## Central Valley Regional Water Quality Control Board

**SUBJECT:** MINOR, NON-SUBSTANTIVE CHANGES TO THE BASIN PLAN  
AMENDMENTS ADOPTED UNDER CENTRAL VALLEY REGIONAL  
WATER QUALITY CONTROL BOARD RESOLUTION NO. R5-2020-0057

**Corrected Version of Figure for “Figure #-#: Schematic  
of Aquifer System Within Corcoran Clay Extent” in Revised  
Basin Plan Amendments**

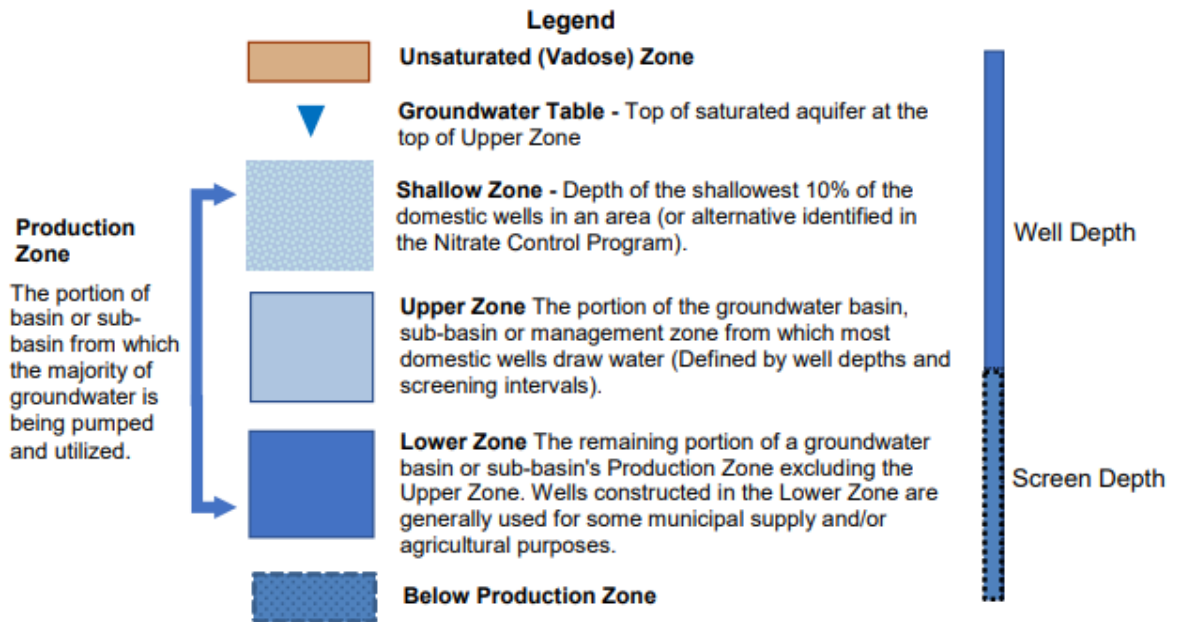
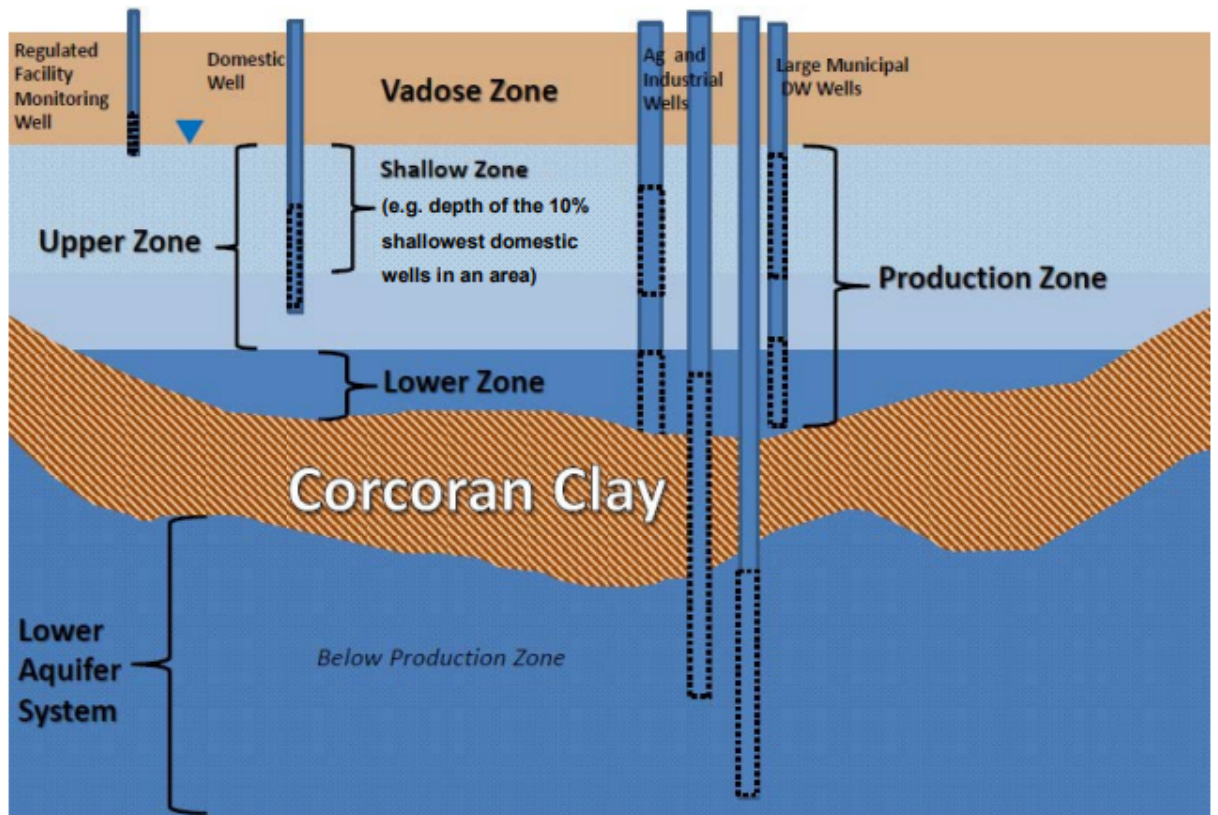
1. Page 76, Figure #-#: Schematic of Aquifer System Within Corcoran Clay Extent, 'Shallow Zone' definition in top graphic - Removal of the words "(average depth of the 10%":

(~~average depth of the 10%~~ (e.g. depth of the 10% shallowest domestic wells in an area)

2. Page 76, Figure #-#: Schematic of Aquifer System Within Corcoran Clay Extent, Footnote 1 – Addition of a space between "below" and "the":

"<sup>1</sup> For the purposes of this program, calculations for Upper, Lower and Production Zones do not extend below\_the Corcoran Clay"

Due to the location of both of these corrections in a Figure, the Figure image in Attachment 1 will replace the current Figure image in "Figure #-#: Schematic of Aquifer System Within Corcoran Clay Extent" to incorporate both of these changes.
